- For Rev B:
1. Change R301, R402, R404 and R501 to 0603 package.
 2. Use non polar diode footprints for TVS and Thyristor parts.

Sheet: /		File: dual-slic-interface.kicad_sch	
Title: Dual SLIC interface			
Size: A	Date: 2024-04-25	Rev: A	
KiCad E.D.A. 8.0.2		Id: 1/5

SLIC CHANNEL	
Sheet: /Top/SLICS/slic/	
File: slic.kicad_sch	
Title: Dual SLIC interface	
Size: A4	Date: 2024-04-25
KiCad E.D.A. 8.0.2	Rev: A
	Id: 3/5

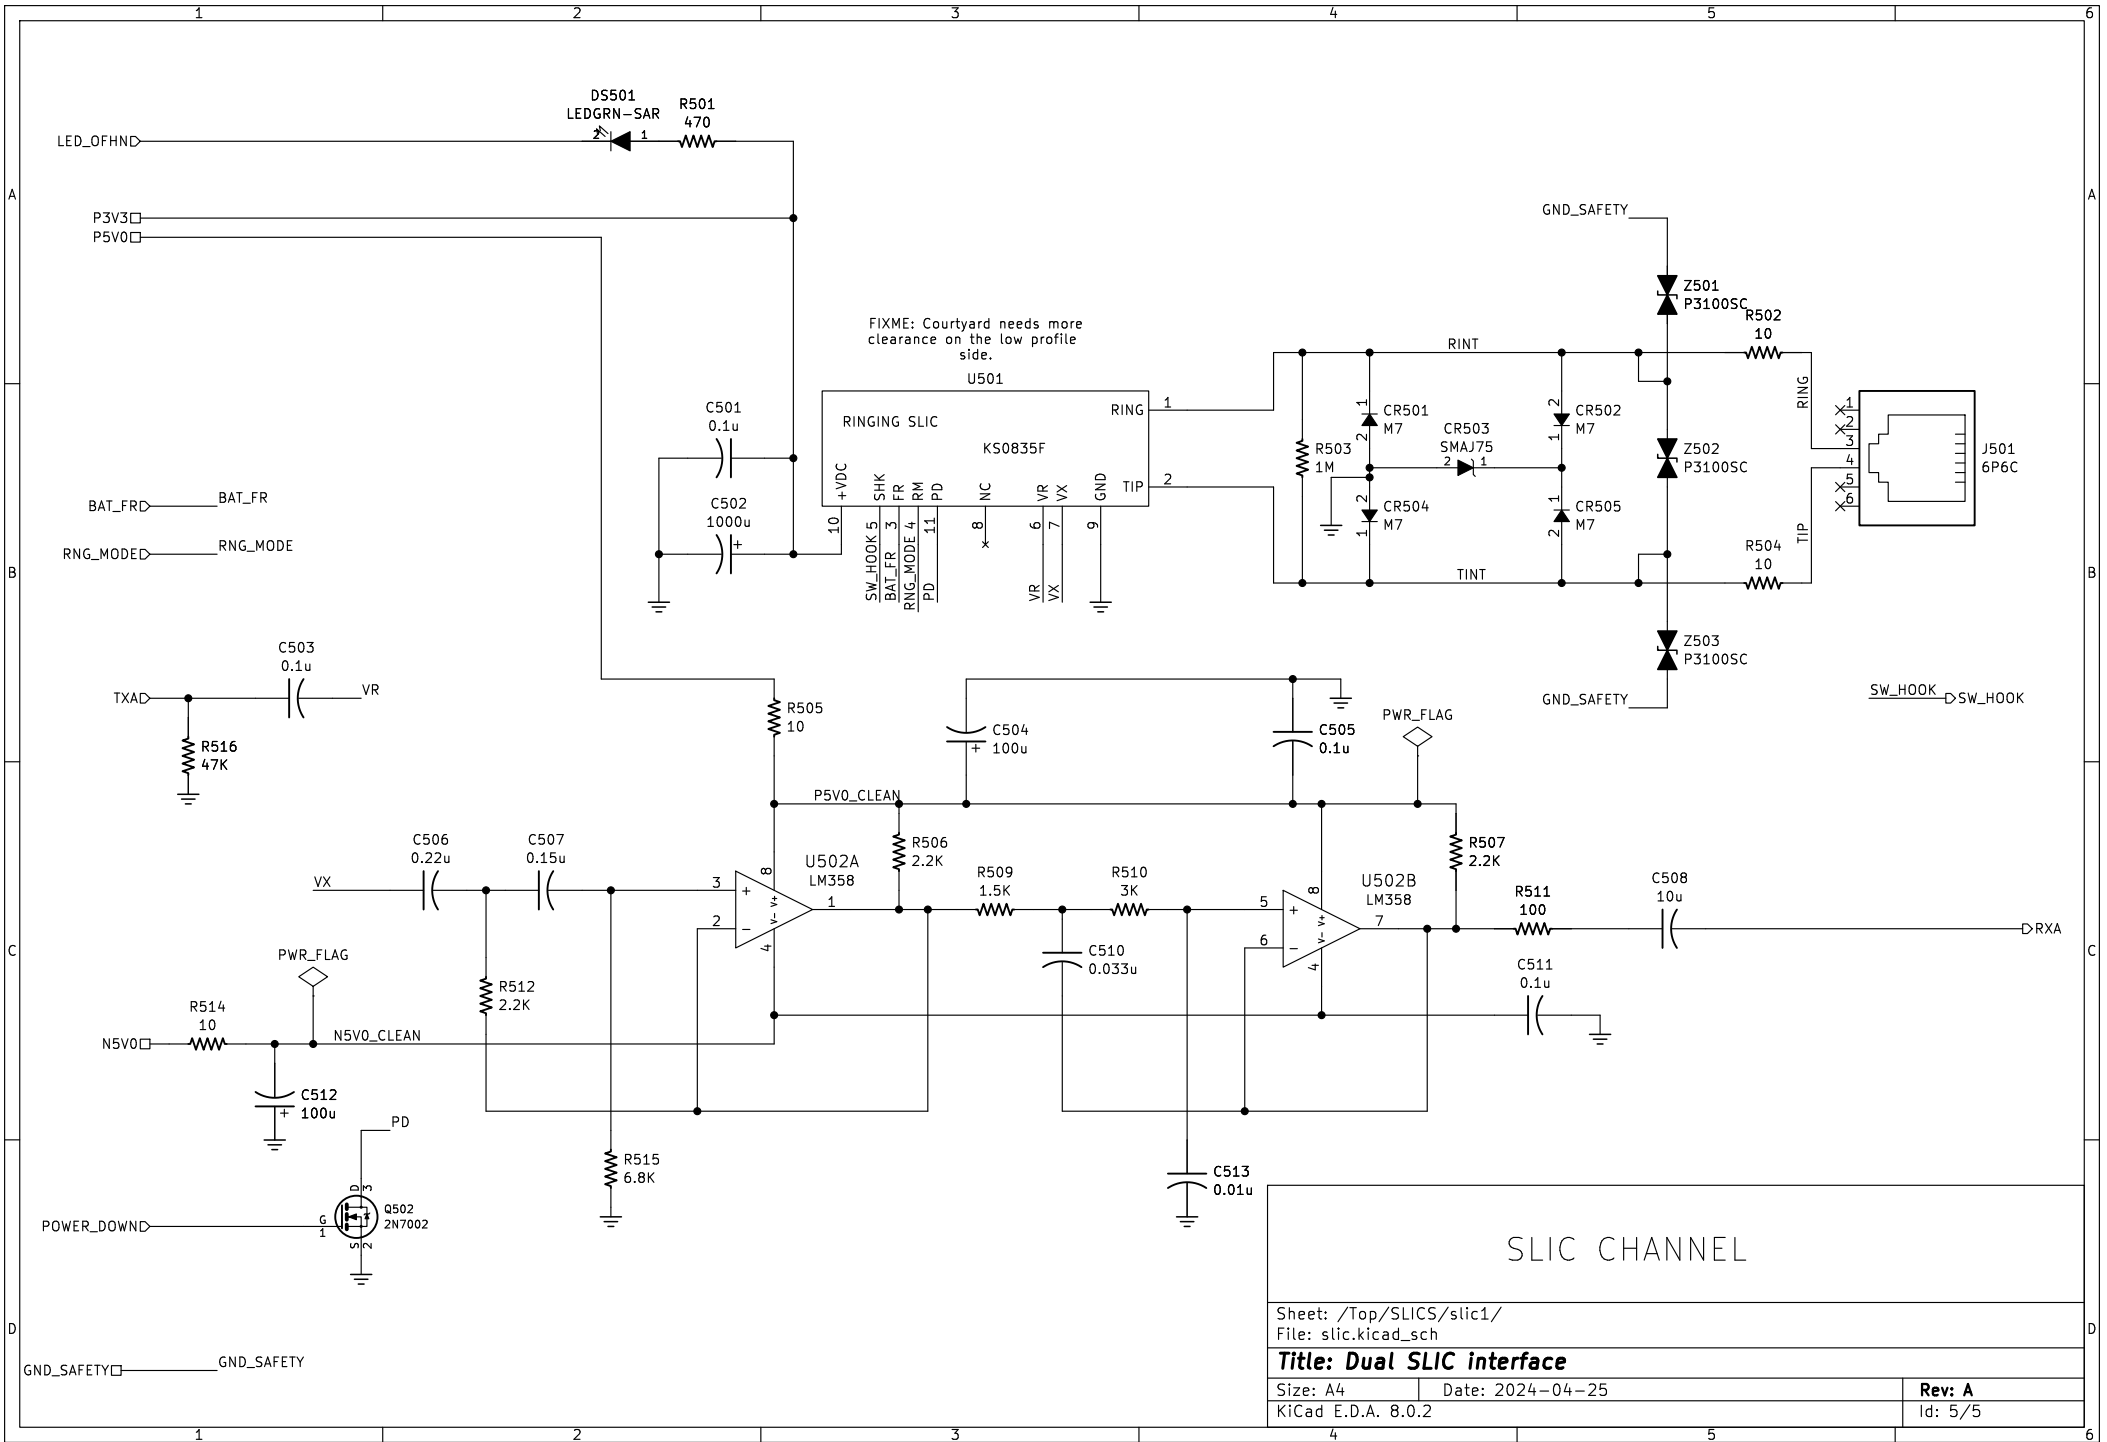
FIXME: Courtyard needs more clearance on the low profile side.
